1 REVISED - SEPTEMBER 15, 2004

FOX RIDGE
PROJECT NAME

PHASE 3 LAKE GRADING - PONDS
SHEET TITLE

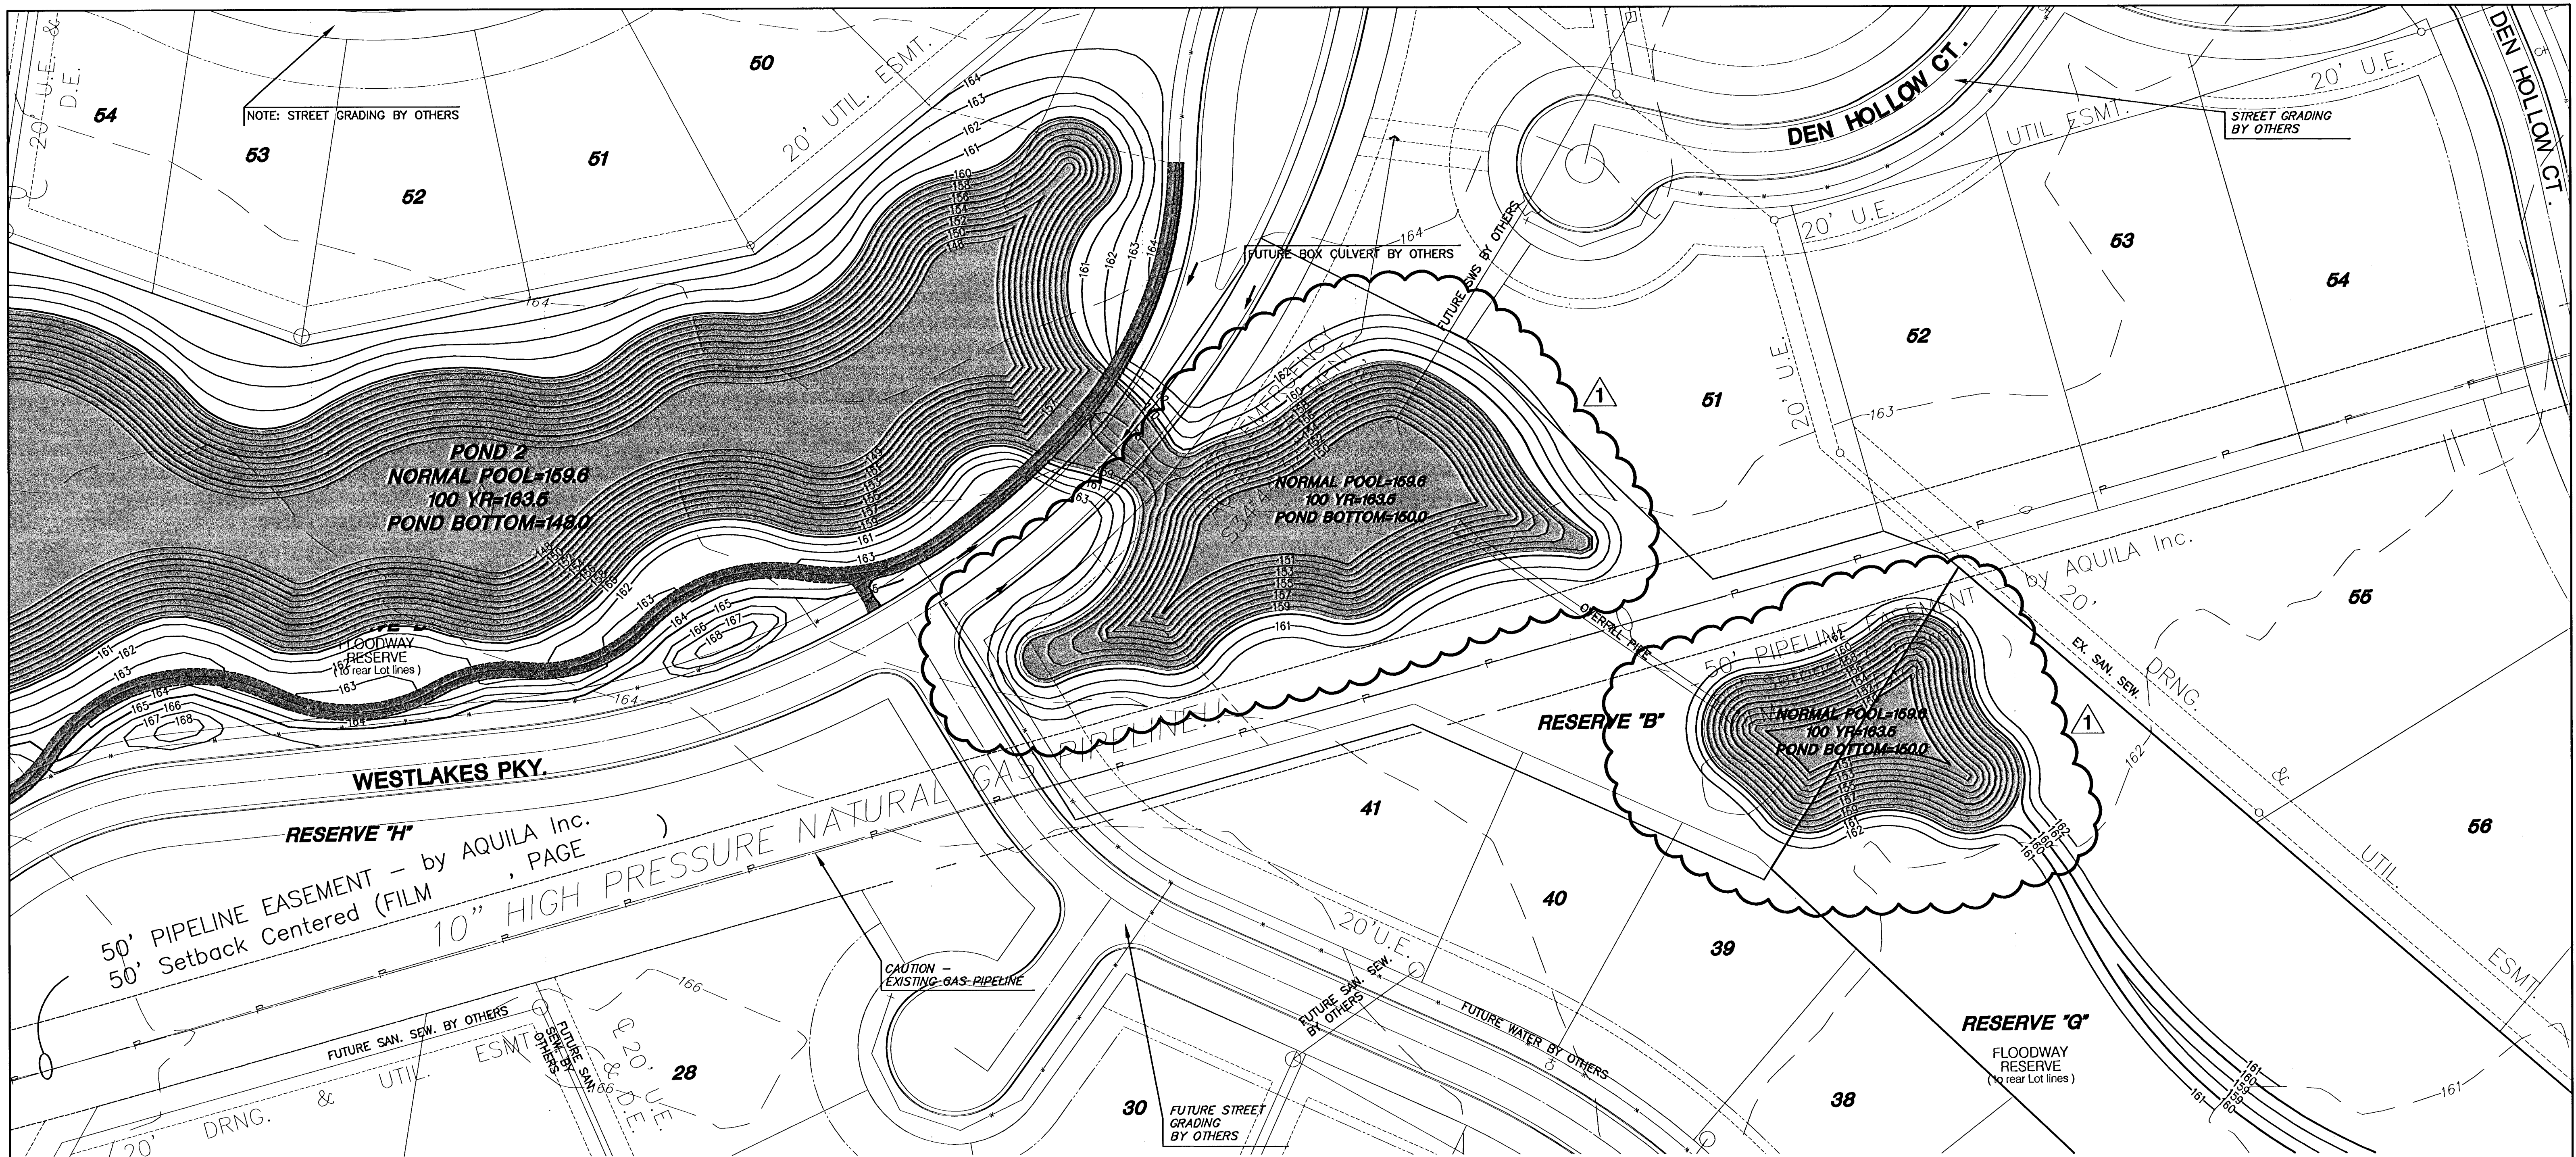
REVISED POND GRADES REFLECT THE ORIGINAL EARTHWORK QUANTITY AS SET AT BID. POND CONTOURS REVISED WITH A REDUCE DEPTH OF POND BY 2 FEET. NEW POND DEPTH SHALL BE ELEV.=150.00
